DEPARTMENT OF THE TREASURY BUREAU OF ALCOHOL, TOBACCO AND FIREARMS CORRESPONDENCE APPROVAL AND CLEARANCE

This refers to your letter of July 16, 2005, to the Firearms Technology Branch (FTB), Bureau of Alcohol, Tobacco, Firearms, and Explosives (ATF), regarding the classification of a submitted Ruger, Model 10/22; .22 caliber semiautomatic rifle; serial number 121-56665; with installed device.

Submission of firearm for evaluation by FTB

Figure I - Ruger and Prototype Triggers

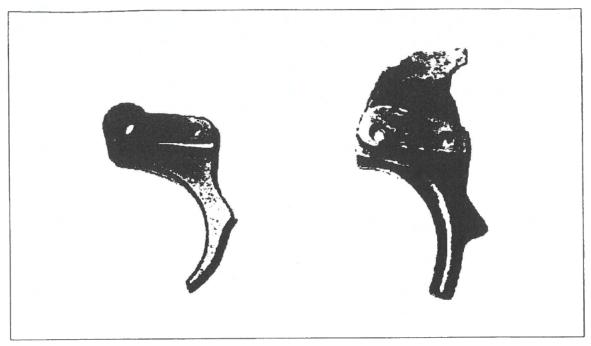
Examination of the submitted firearm by FTB revealed that it had been modified by the installation of a replacement trigger and sear mechanism. The trigger is approximately 1.993 inches (51mm) in height, having a raised shoulder on the right side. Further, an angled cut is present on the forward edge of this shoulder. The sear mechanism has been made from a folded and formed piece of metal approximately .675 inch (17mm) x.310 inch (8mm) x.444 inch (11.5mm). It is secured within the trigger group by the magazine latch/ejector pivot pin. A wire spring (looped around the hammer crosspin) applies vertical pressure to the sear. Also, a metal pin approximately .437 inch (11mm) x.128 inch (3mm) has been installed through the top area of the hammer. The purpose of this pin was not determined.

My original trigger modification did include a new trigger, but did not include a new sear mechanism. The trigger is similar to Ruger's original trigger. It differs in that it has a lug that projects upward from the right flange and it is made from steel instead of aluminum. See Figure I for a comparison.

Figure V - Prototype Trigger & Trigger Stop

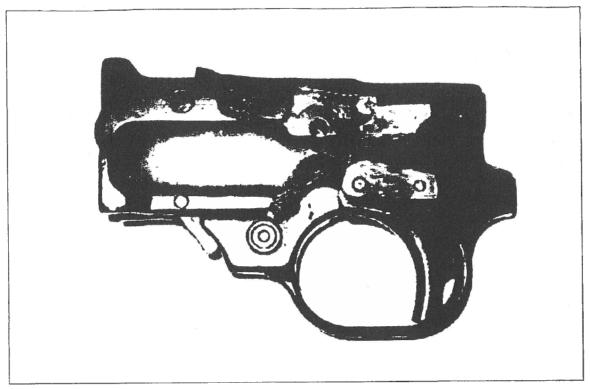
The .675 inch (17mm) x.310 inch (8mm) x .444 inch (11.5mm) formed sheet metal component that was described as a "sear" is not intended to be a sear, but is a trigger stop mechanism. Figure IV shows the trigger stop.

The wire spring is very similar to the original wire spring used by Ruger to hold down the bolt stop. It is just made of heavier wire and wound in the opposite direction. This allowed the new spring to perform a second function, put tension on the trigger stop.

Figure VI - Trigger, Trigger Stop, & Hammer With Crosspin

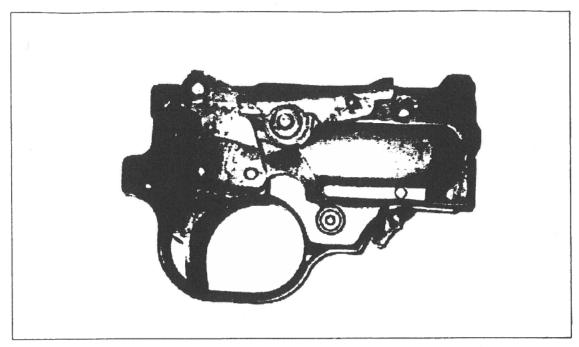
The final question to answer is the function of the pin through the upper part of the hammer. Figure VI shows the prototype trigger, trigger stop, and hammer with crosspin in relation to one another when they are in the trigger housing.

The crosspin on the hammer hangs over the back portion of the trigger lug. When the bolt pushes the hammer back, the crosspin pushes down on the trigger lug, rotating the trigger forward until the trigger stop rotates down and locks the trigger in place, in the cocked position. In fact the trigger cannot be moved, once the trigger stop has fallen in place until the bolt is nearly closed. As the bolt closes, it pushes down on the forward end of the trigger stop and rotates it out of engagement from the trigger, allowing the trigger to be pulled at any time.
